PETITION NO: Z-55

PROPOSED USE: Residential
Condominiums

APPLICANT: Lynwood Development Group, LLC

PLANNING COMMENTS:

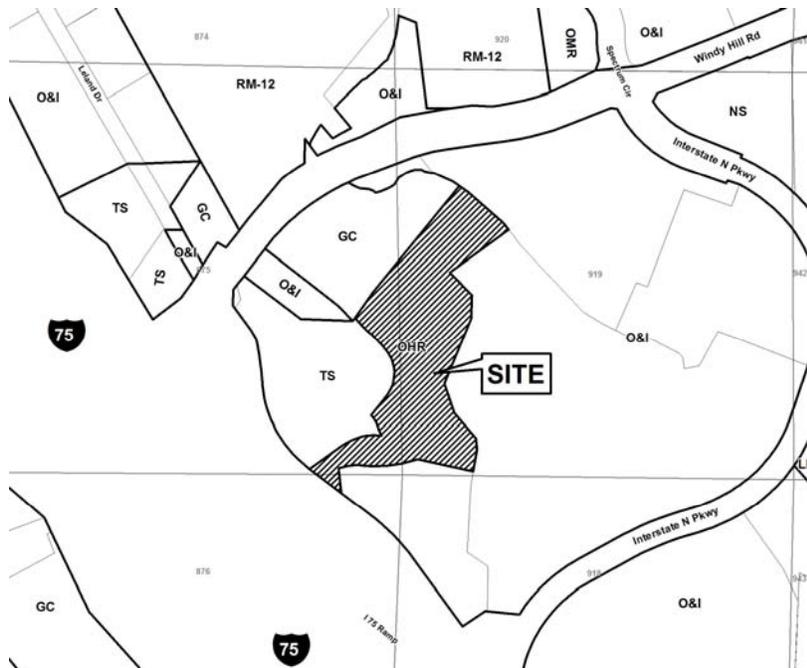
- No Stormwater controls shown - **must be addressed at Plan Review**
- Copy of survey is not current - Additional comments may be forthcoming when current site conditions are exposed.
- No site improvements showing on exhibit.

1. This site is located adjacent to Rottenwood Creek. Only a small portion of the site actually lies within the 100-year floodplain and floodway of the creek. However, the cul-de-sac location on the current site plan encroaches into the 25-foot impervious stream buffer setback. The site plan will need to be revised to relocate this pavement outside the impervious setback limit.
2. No onsite stormwater management is shown on the current plan. It is assumed that some type of underground detention will be provided below the proposed parking deck. It is possible that stormwater management may already be accounted for in the adjacent Interstate North Office Park Lake located immediately to the east of the site. This will need to be verified in Plan Review.
